City of  
Richmond

## Report to Development Permit Panel

**File:** DP 11-564405

**Re:** **Application by Dava Development Ltd. for a General Compliance Ruling at Portions of 10111, 10197 & 10199 River Drive (formerly Portions of 10111 & 10199 River Drive)**

Plan 24e Sept 15, 2016  
DP 11-564405

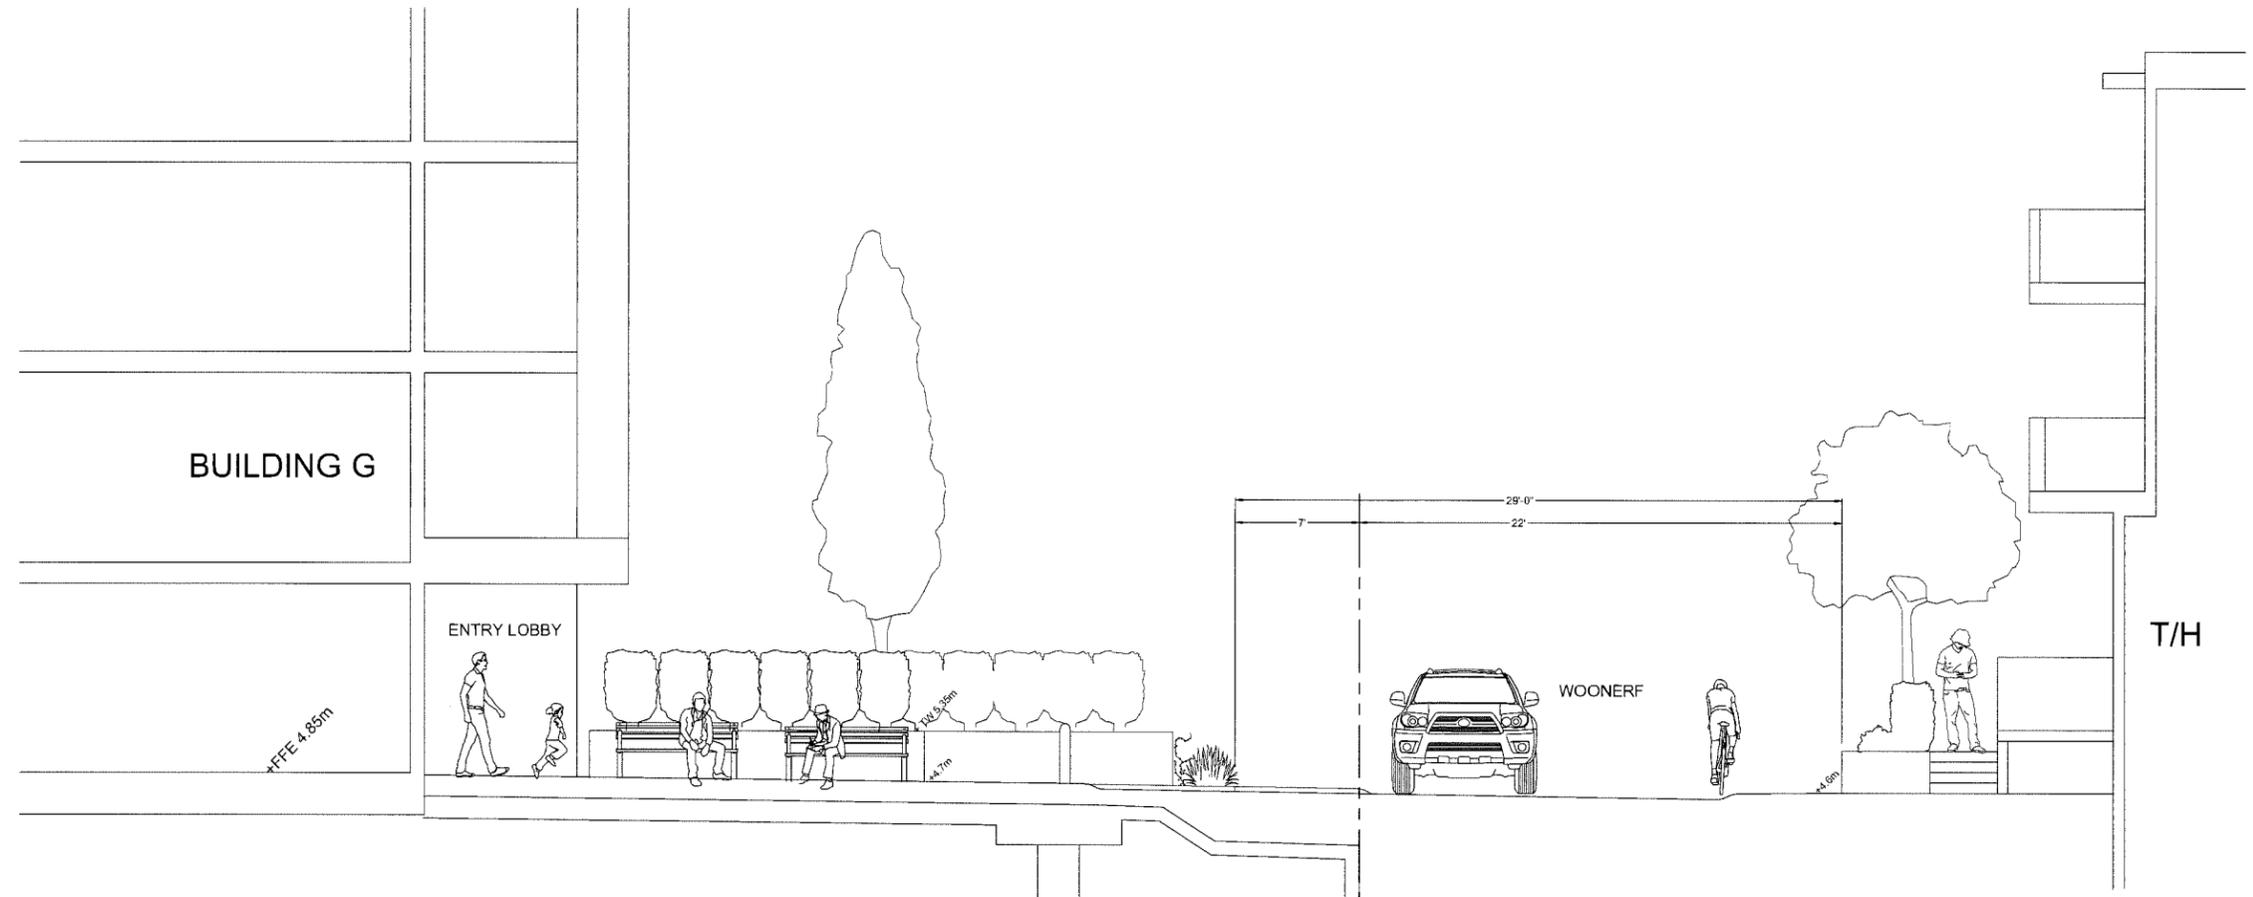
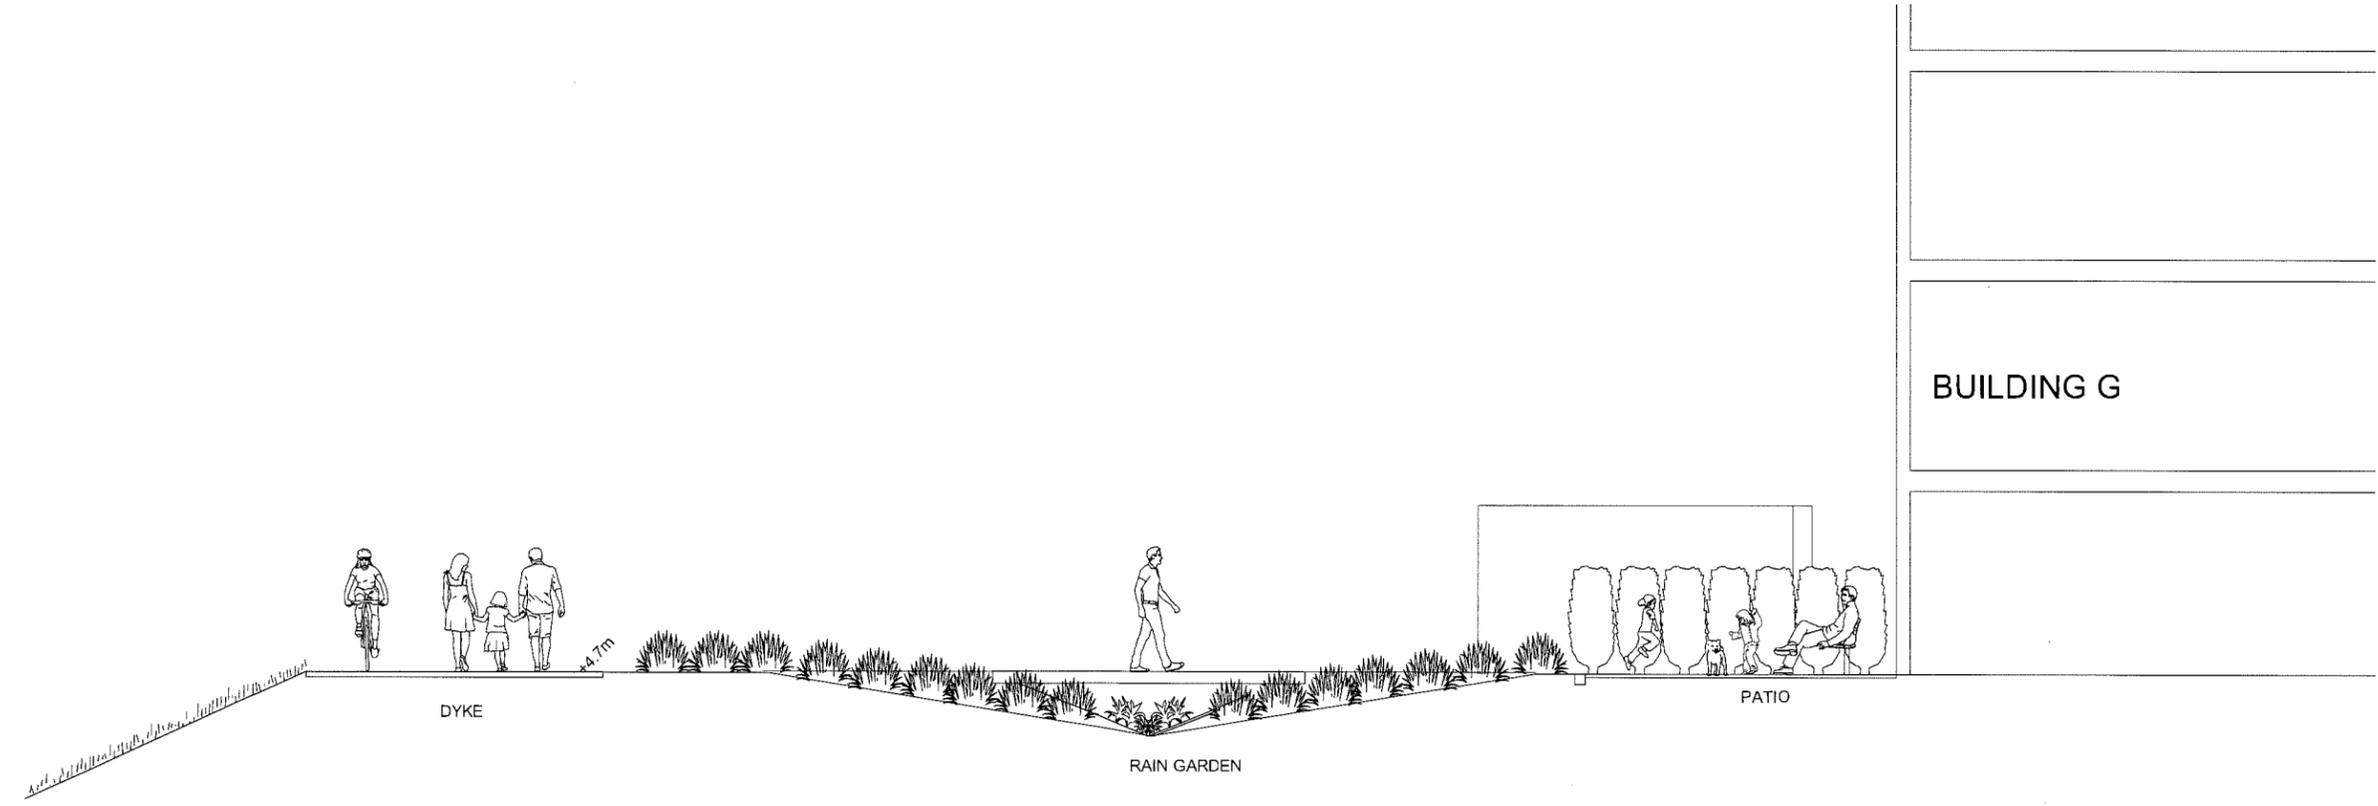
Supplements Plan 24 with sections at Building G

Reference Plan Sept 15, 2016  
DP 11-564405

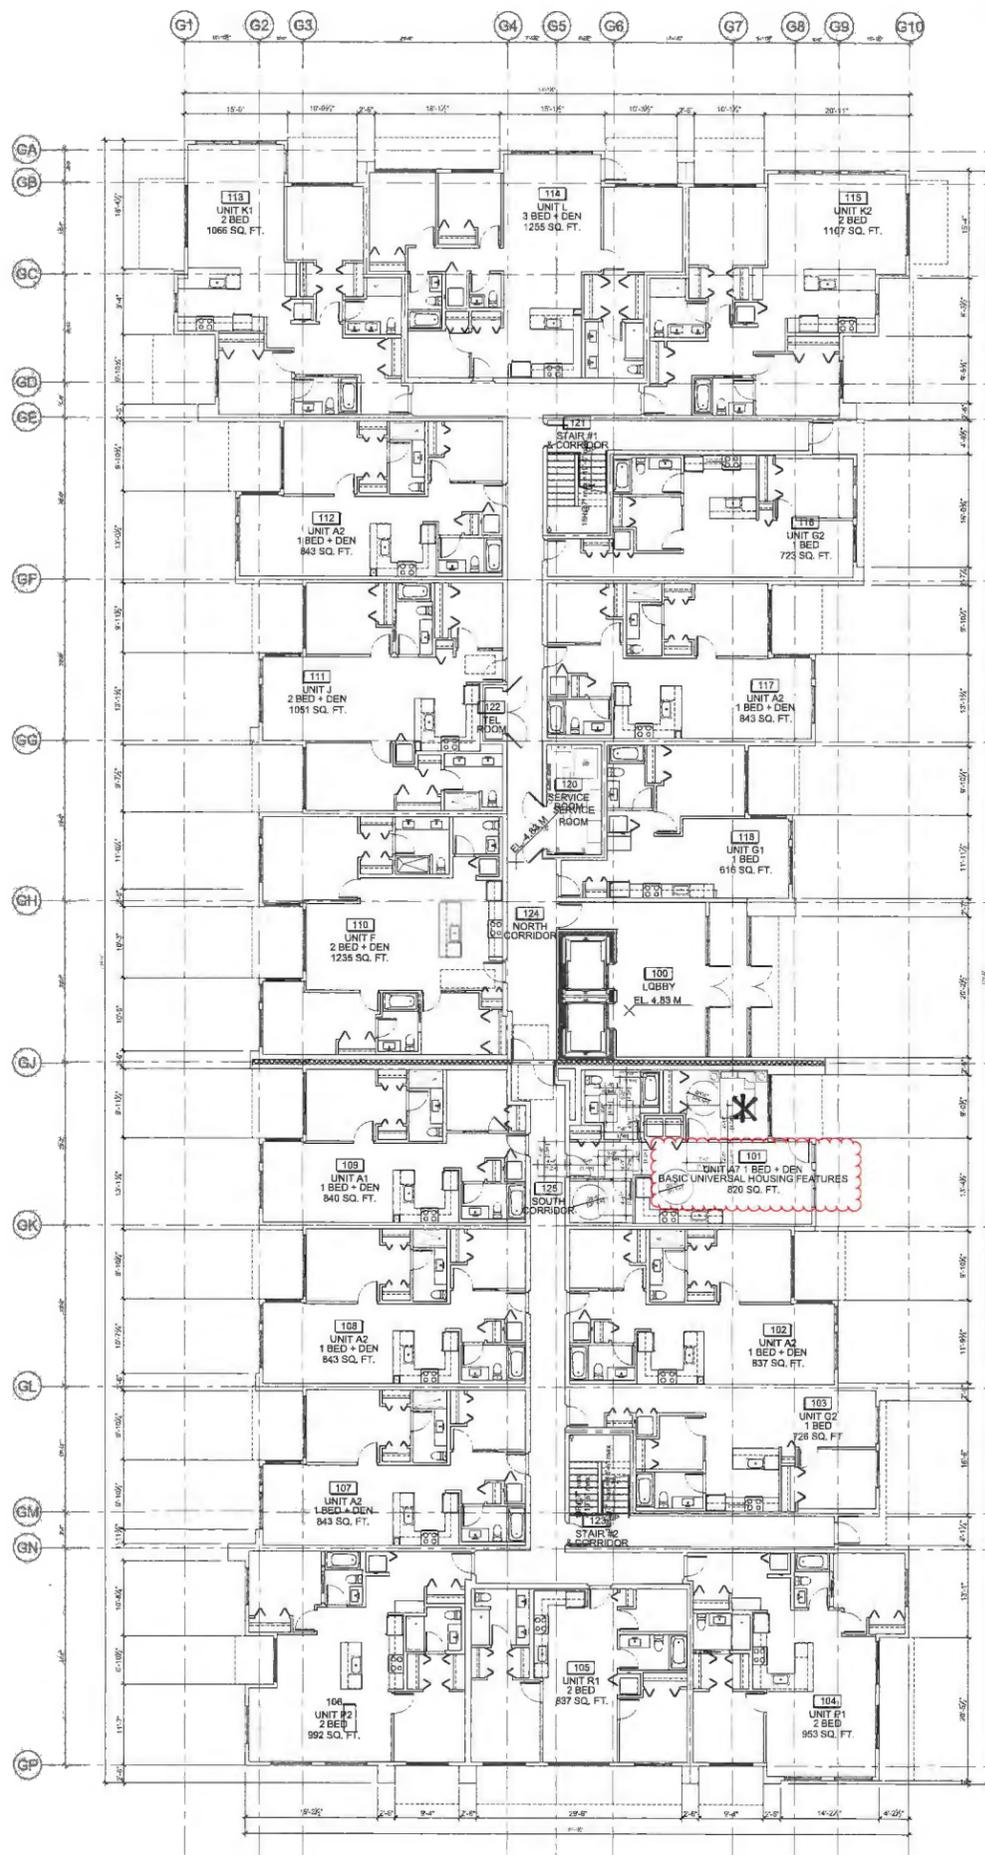
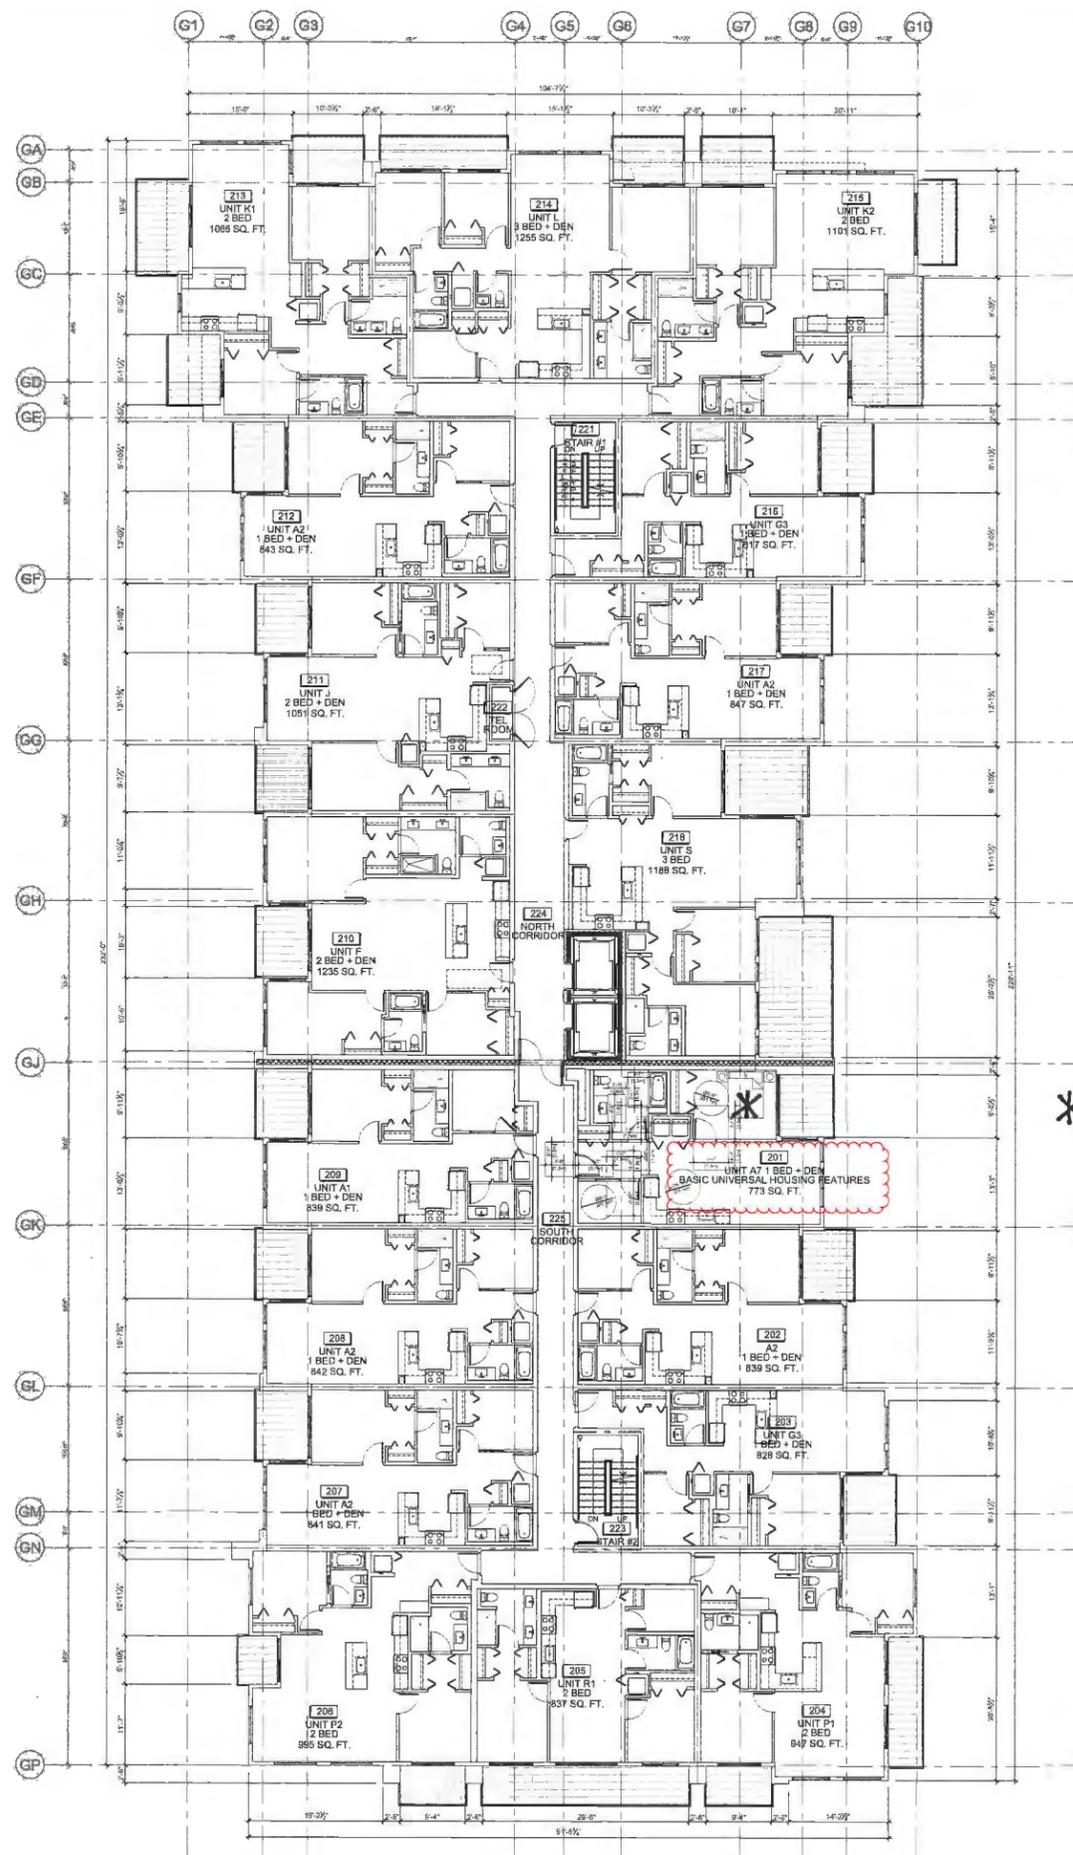
Replacement reference plan  
with Basic Universal Housing  
Feature Units

\* BVHF UNITS (2)  
TO COMPLY WITH  
ZONING BYLAW  
SECTION 4.16

- The approved development includes two (2) basic universal housing units in building “G” that are designed to be easily renovated to accommodate a future resident in a wheelchair. These two (2) units are now proposed to be located on floors 1 & 2 as identified on the replacement floor plans. These single-storey units are required to incorporate all of the accessibility provisions listed in the Basic Universal Housing Features section of the City’s Zoning Bylaw, and are permitted a density exclusion of 1.86 m<sup>2</sup> (20 ft<sup>2</sup>) per unit.
